Derenzo and Associates, Inc.

June 14, 2011

Subject: Trail Ridge Energy, L.L.C.
Response to request for additional information
Proposed new engines and requested increase of CO emissions standards for existing engines; Project No. 0310358-012-AC (PSD-FL-374C)

Figure 1. ROI for maximum 1-hr NO₂ impacts from the proposed TRE emission units (9.2 km)

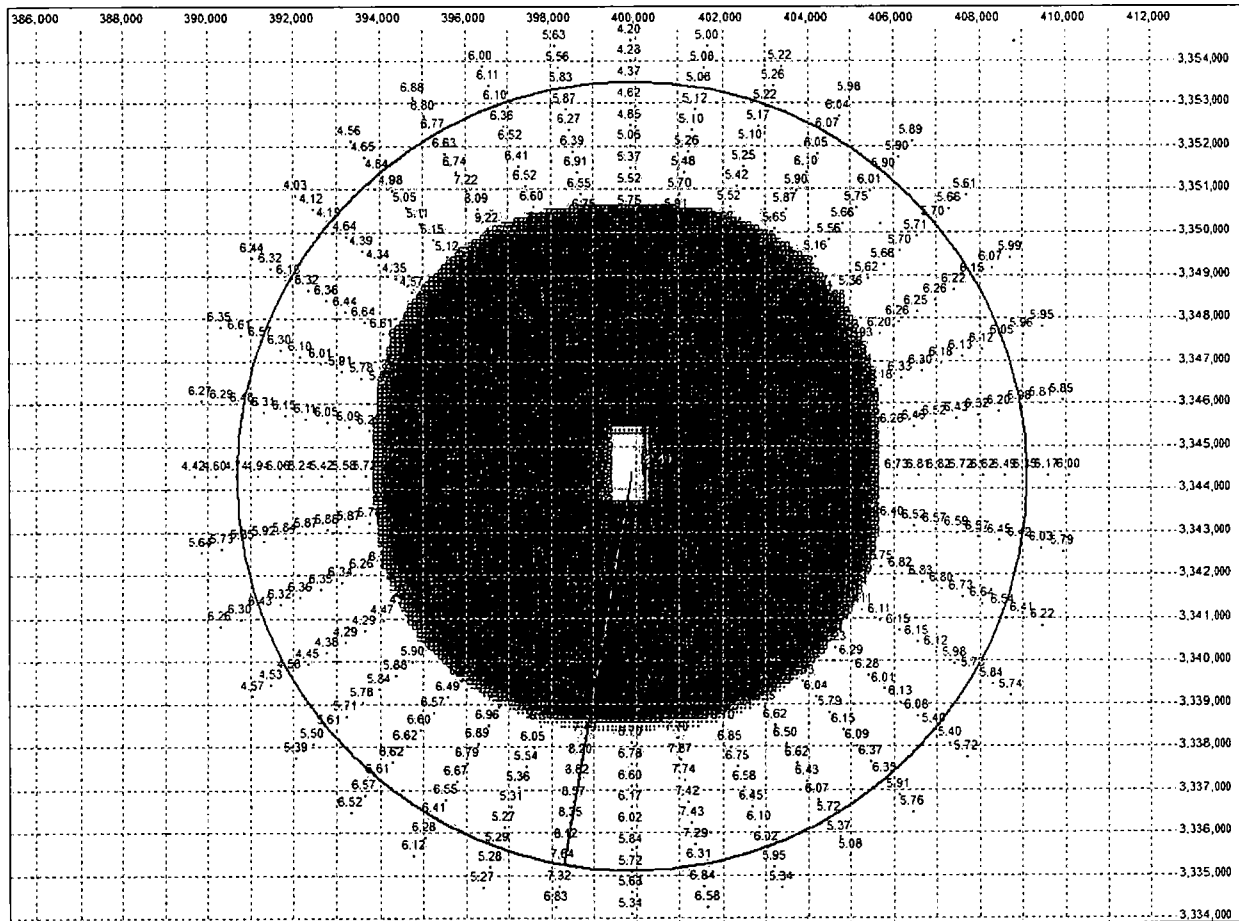
The FDEP has requested that TRE compare its predicted one-hour NO₂ impacts against the significant impact level and that a one-hour NO₂ radius of significant impact be determined. The FDEP correspondence notes that the USEPA recommends that an interim significant impact level of 7.6 µg/m³ be used for comparison against predicted one-hour NO₂ impacts (June 28, 2010 memorandum).

Prior to performing the one-hour NO₂ significant impact level modeling analysis the existing receptor grid (as presented in the January 18, 2011 modeling protocol) was expanded. The original receptor grid extended approximately 6 kilometers (km) from the facility and receptors were placed every 70 meters on a Cartesian coordinate system. To determine the radius of significant impact for NO₂ additional receptors were added to the original grid. The additional receptors were placed on a polar grid with arc spacing of 10 degrees and linear spacing of 500 meters. The polar grid of receptors extended from 6 kilometers to 10 kilometers from the facility. Execution of the model resulted in a predicted one-hour NO₂ radius of significant impact (ROI) of 9.2 km from the TRE facility.

Figure 1 presents the maximum predicted radius of impact for the proposed emission units at the TRE facility.
